# Cross River Rail Environmental Impact Statement

Request for Project Change 9

Changes to the Project and changes to the  
Imposed Conditions – Southern Portal Area

Response to Submissions Report

Figure 4: Map of the Southern Portal Area

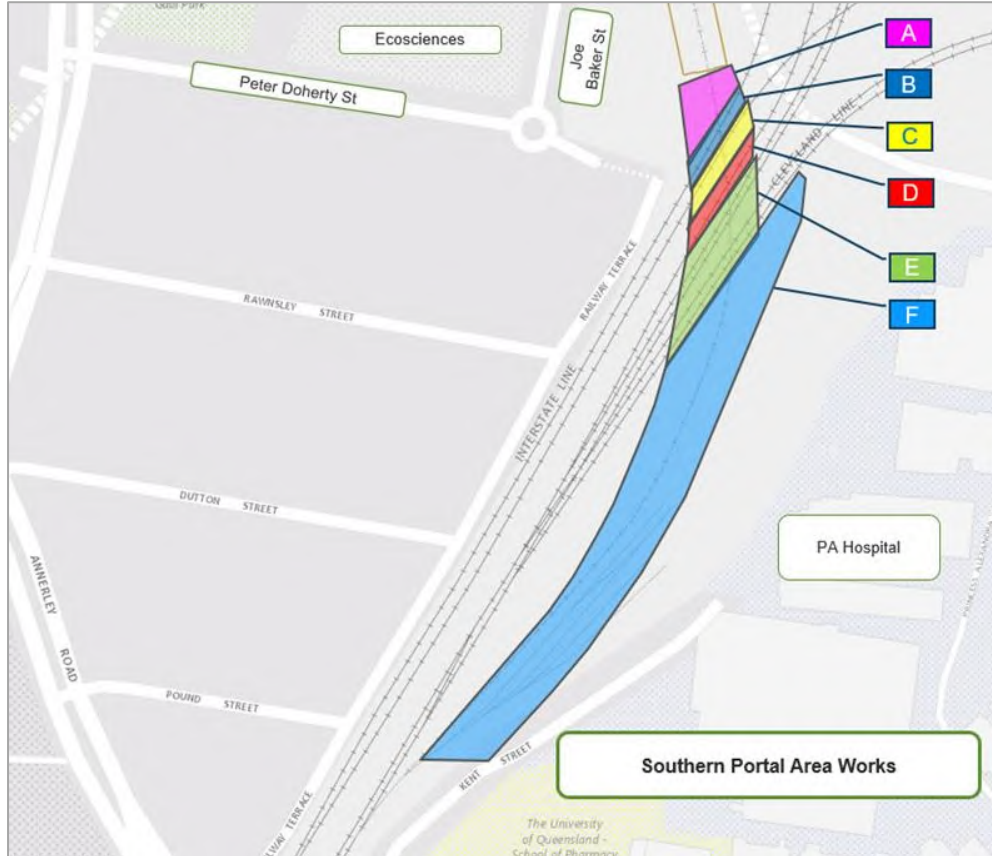
In the RfPC9 application, the preferred access option was identified to be Option 1, involving a reconfiguration of the Annerley Road/Peter Doherty Street intersection.

Option 1 was the preferred solution for providing access into the Boggo Road/Southern Portal Area worksites, as it provided two separate accesses for heavy vehicles to manage the peak heavy vehicle traffic loading during August/September 2021 – one access via Boggo Road to the Boggo Road Station and cavern worksite, and the second access via Peter Doherty Street directly to the Southern Portal Area worksite.

While access Option 3 addresses key matters raised in submissions regarding traffic impacts, Option 3 introduces significant time/delivery risks to achieving the successful completion of the 'middle road' rail possession (Zone D above), associated with the introduction of peak heavy vehicle loadings on the one-way access system during August/September 2021.

In response to matters raised in submissions, the Project will instead utilise access Option 3 (the current endorsed heavy vehicle access to the Project worksites via Boggo Road, Joe Baker Street, and exit via Peter Doherty Street).

To successfully commence and complete the 'middle road' rail possession, heavy vehicle access is required to be constructed through Zones B and C. This activity was planned to be conducted during standard work hours (6.30am to 6.30pm), however, to address time constraints associated with the peak vehicle loadings introduced as part of utilising heavy vehicle access Option 3, the Project will now be required to undertake an additional 14 days of 24/7 works in Zones B and C.

The works requiring a longer 24/7 rail possession are now identified to occur in Zones B and C, in addition to Zone D.

Works in Zones B and C will involve a 14-day, 24/7 operation to undertake track demolition works and to construct safe access to Zone D, in addition to the 40-day closure of the 'middle road' track to undertake cut and cover construction activities. The estimated schedule and staging of works is provided below. The work stages within Zone D will overlap.

Figure 6: Boggo Road / Southern Portal Area works – notification/engagement areas

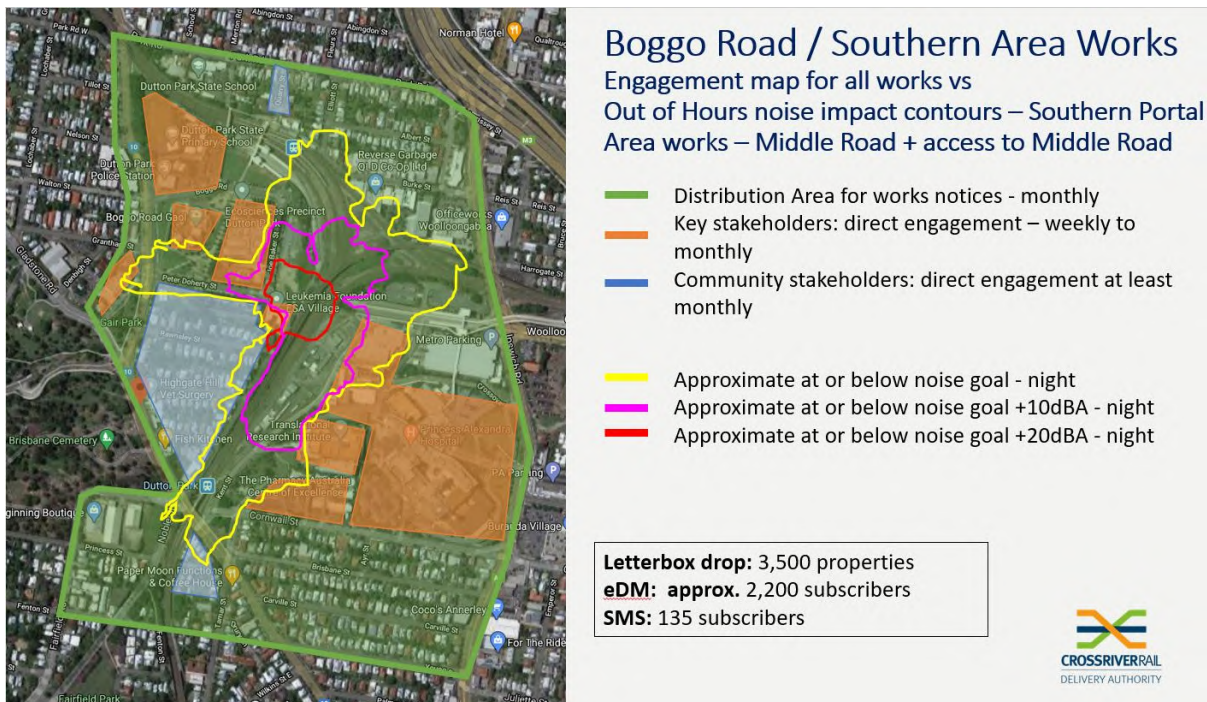
Submitters raised concerns about noise impacts from construction works at the Southern Portal Worksite and how noise impacts from work at night would be communicated and managed.

As part of the existing Project Works, and in preparation for the Southern Portal Area works, updated noise modelling will continue to be developed, with notification and engagement activities to continue as shown in Figure 6.

Consistent with the current endorsed Construction EMP, for Southern Portal Area works involving a period of 24/7 activities that include out of hours works:

- Notifications will be distributed across the area identified in Figure 6;
- Direct engagement will occur with key and community stakeholders shown in Figure 6, including consultation regarding predicted impacts and mitigation arrangements;
